**CALIFORNIA DEPARTMENT OF WATER RESOURCES
OROVILLE FACILITIES RELICENSING (FERC PROJECT NO. 2100)
PUBLIC SCOPING MEETING OF OCTOBER 29, 2001**

*** Comments of Joint Water Districts
and
Western Canal Water District**

Re: DWR Obligations to Deliver Water from Thermalito Afterbay at
Temperatures Suitable for Agriculture

I've marked 7 photos taken on December 30, 1999 by Mattson which chronologically show the introduction of water from the Afterbay through the Richvale Canal and into each of the three fields which shows the area of ground tilled by cold water temperatures.

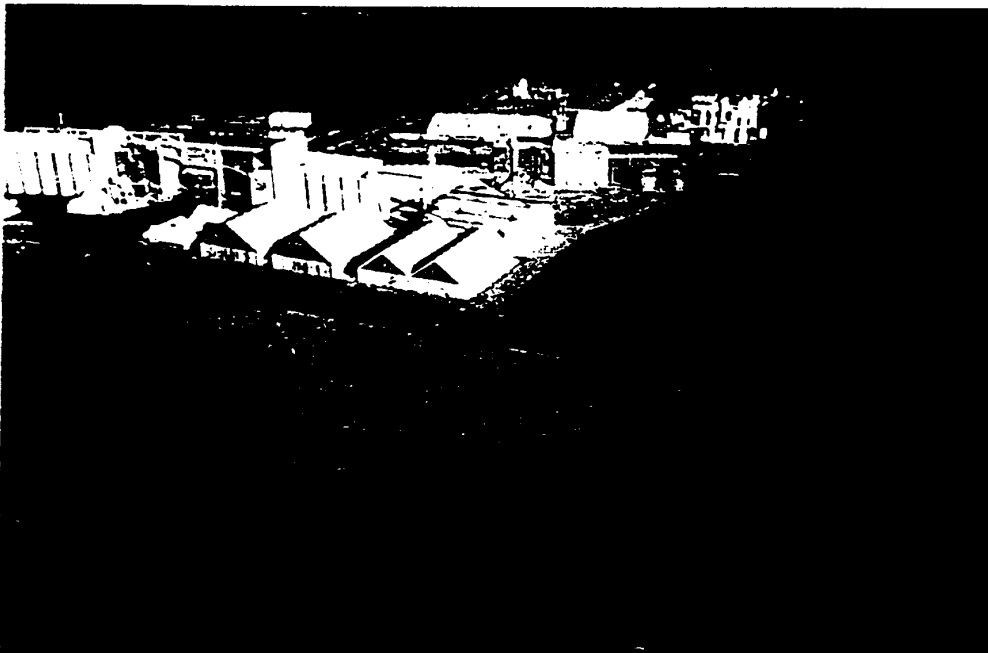
The 80-acre field takes about 2-3 hours to run water through the warming pond which is at the southeast corner of the field and takes water right out of the intake channel from the Western Supply Ditch at approximately 56° - 58°. The warming pond probably takes 5° - 8° off the cold water temperature and grows rice but does not produce any rice for the entire 2 - 3 acres. Butch says he started the pond 6 - 7 years ago in an attempt to control colder water temperatures coming out the Afterbay. His yield average in 1999 on the 80-acre field was 106 sacks green and 94 dry with no rice harvested on the 2 - 3 acre warming pond area.

Butch's second field is the 300-acre field which has a 5 - 6 acre warming pond built in approximately 1995 to control cold water. Rice was planted but now growth in the entire 5 - 6 acres and water coming from the intake channel is estimated at 58° and warmed to approximately 66° in the 5 - 6 acres before applied on the balance of the 300-acre growing area. In 1999 rice yields were 86.5-acres dry with rice planted but killed on the entirety of the 5 - 6 acres.

The third 270-acre field has no leveed warming pond because the landlord (Wehas Farms) said the levee area produces weeds which encroaches on rice production in other areas so the levee was taken down. Still, 5 - 6 acres is planted to rice but grows no rice and the temperature at the intake channel is 58° with another 66° - 67° where it comes out of the 5 - 6 acre into the balance of the field.

EXAMPLE #5

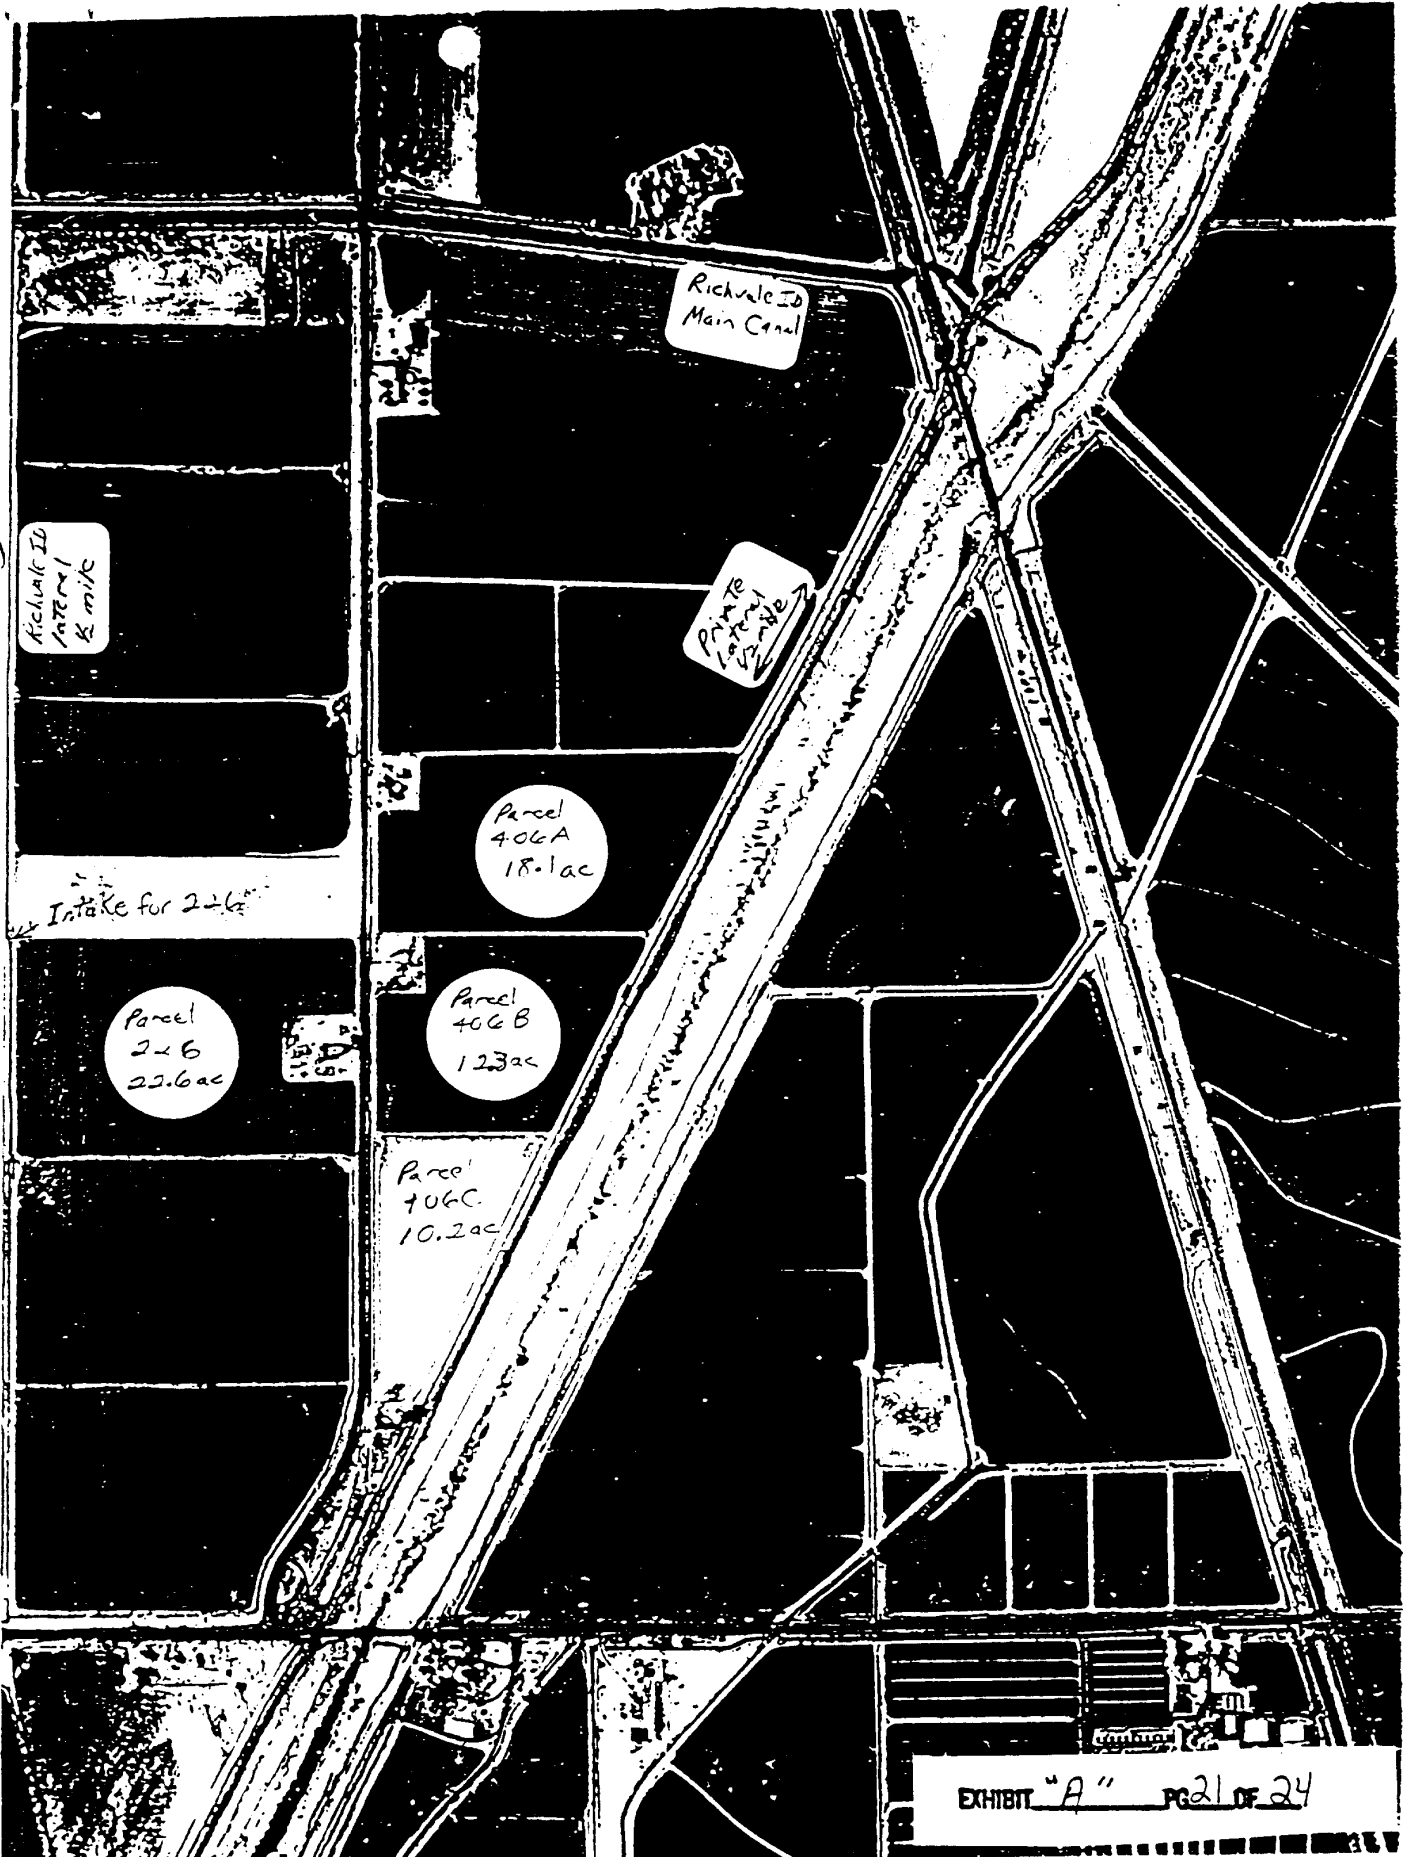
Parcel 226: Contains 22.6 acres of farmable rice acres which receives its water from a district lateral and a required bottom gate (producing colder water compared to a top of ditch service). Yield on this parcel for 1999 was 34.68 cwt. per acre of M401 rice. This parcel is farmed, planted, and harvested under all the same time frame as parcel 406 which borders parcel 226 on the east side.

Attached is map showing the location of parcels 226 and 406 in relationship to the main canal and each other. As stated above there were no differences in farming practices, fertilizer application, irrigation levels, planting dates, chemical applications, draining dates, harvest conditions and dates, and drying/storage practices.

The intake area(approx. 2 acres) of parcel 226 was totally blanked and was unharvestable. The remaining acres had approximately 50% blanking and harvest moistures where higher due to immature kernels. Also attached are paddy rice confirmations showing those moistures and yield data.

EXAMPLE #6

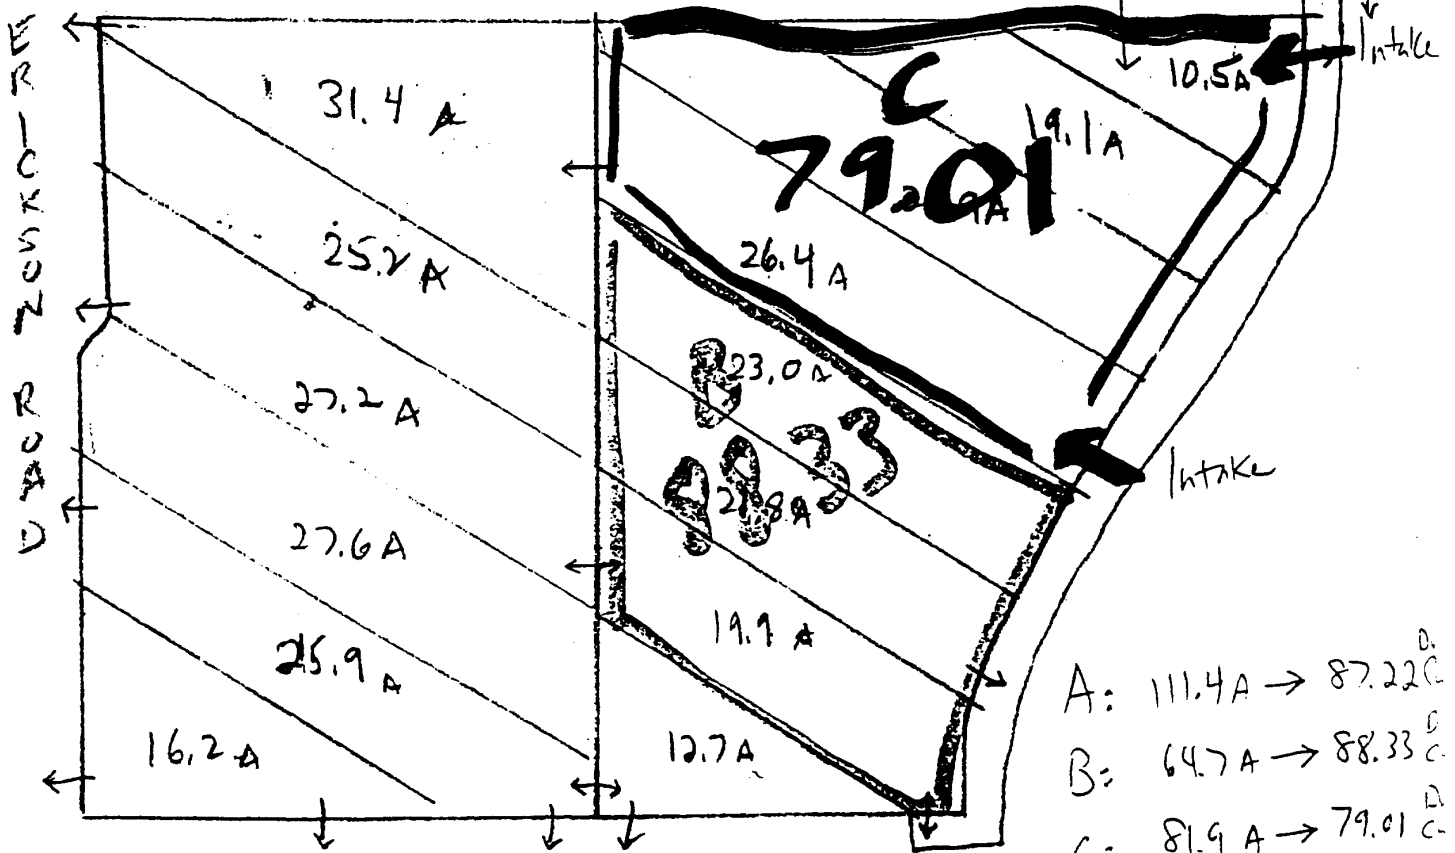
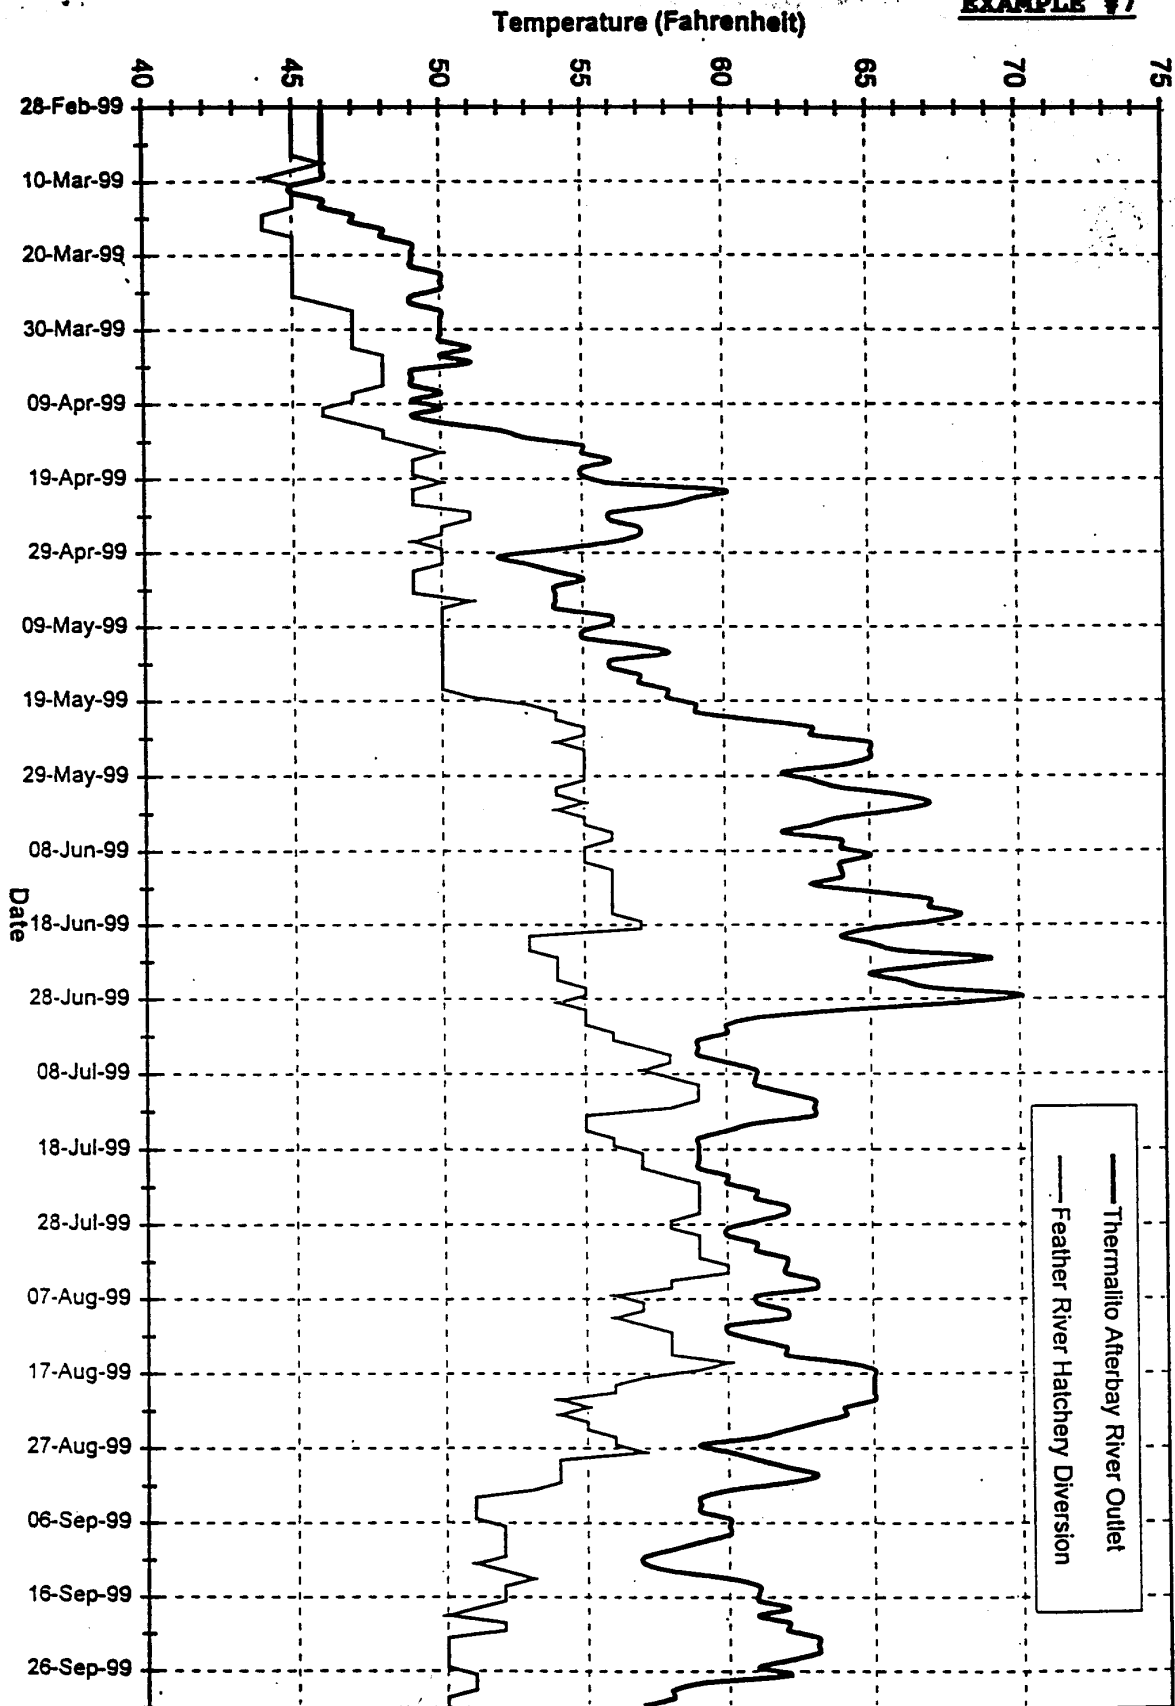
Memorandum #6 is a map which reviews WCWD and RID Landowner Gary Lindberg with cold water temperatures suffering reduced crop yields in both the east and west side of a 314 acre field divided into three sections.

10.5A Intake
Check yielded
55.11 green & 25.9% moisture

Oroville Complex Temperatures

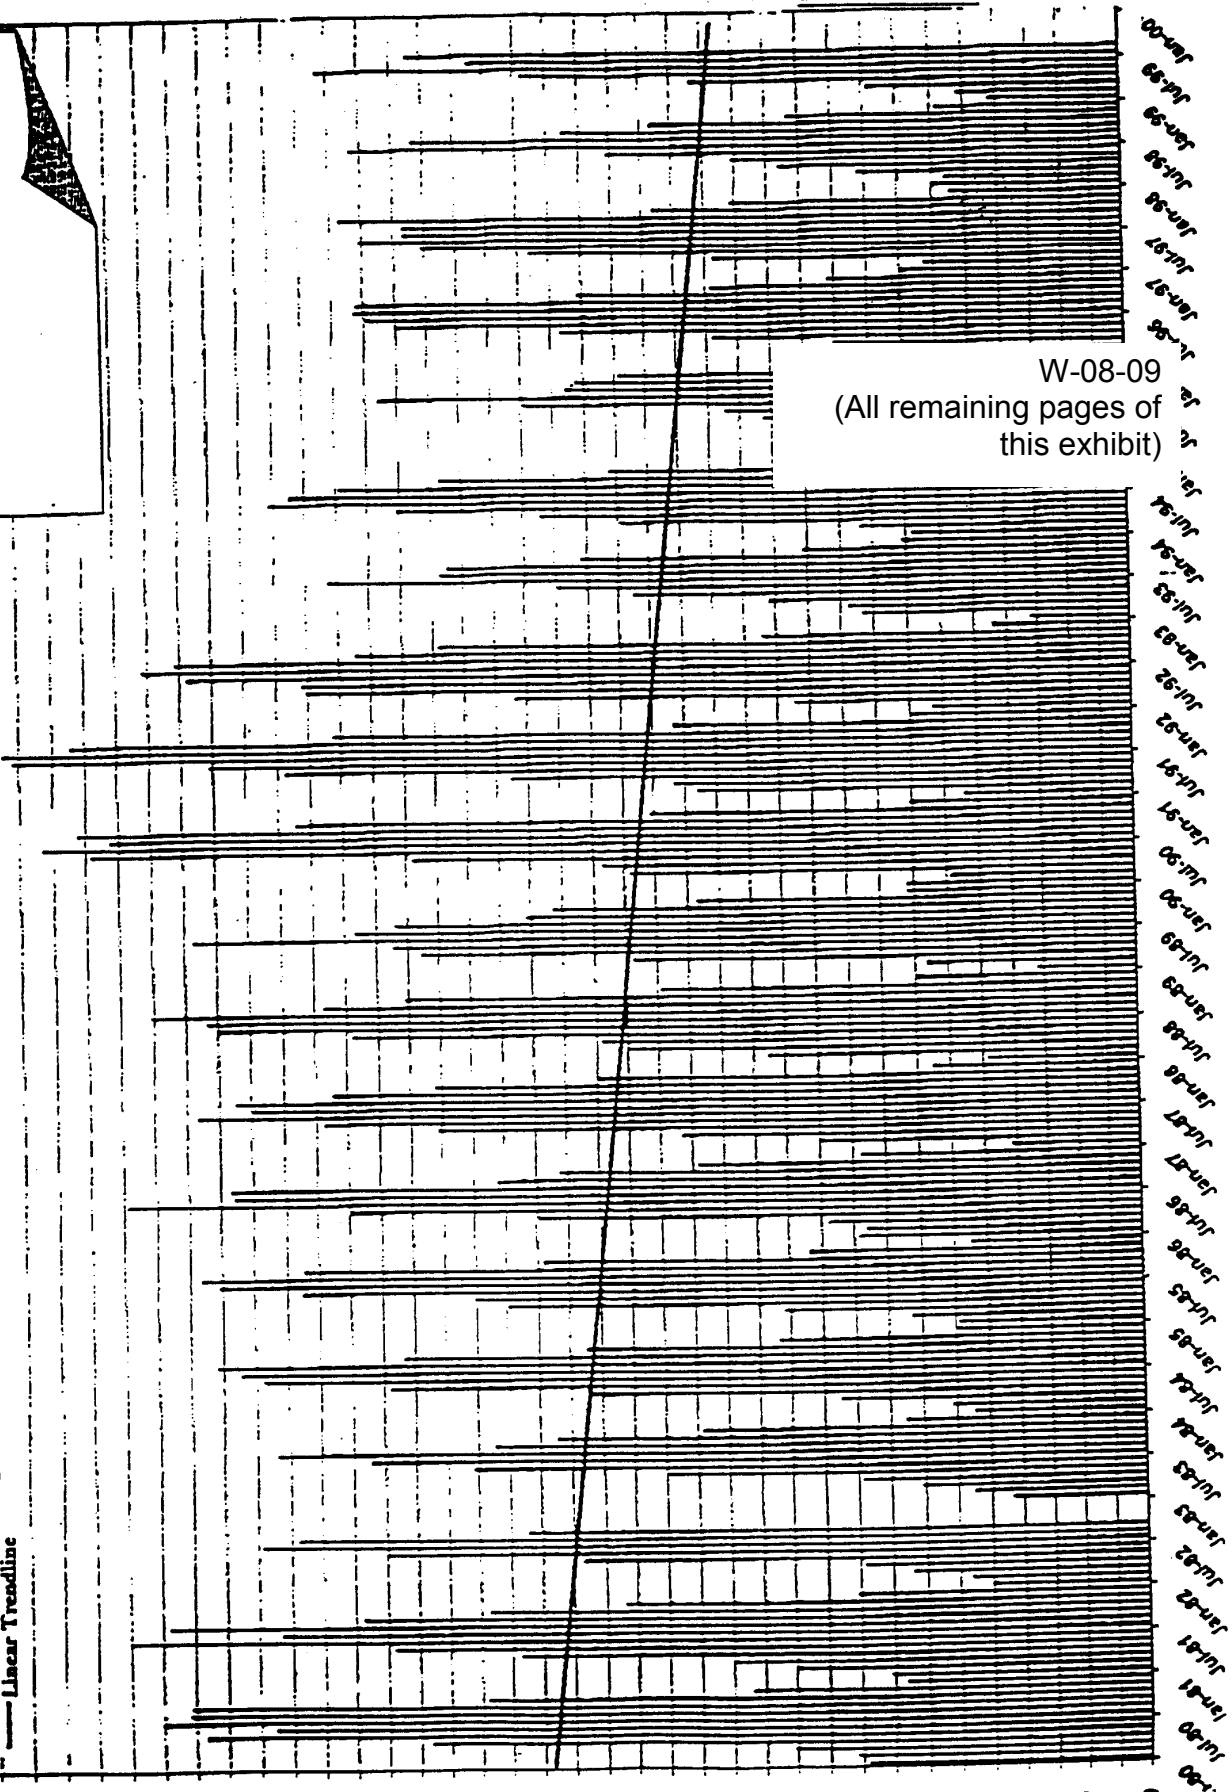
Memorandum #8 is a twenty (20) year graph supplied by the DWR Oroville Field Division which identifies the trend toward colder water released from Lake Oroville (commencing January 1980 through January 2000). A more dramatic drop in water temperatures started in January 1993.
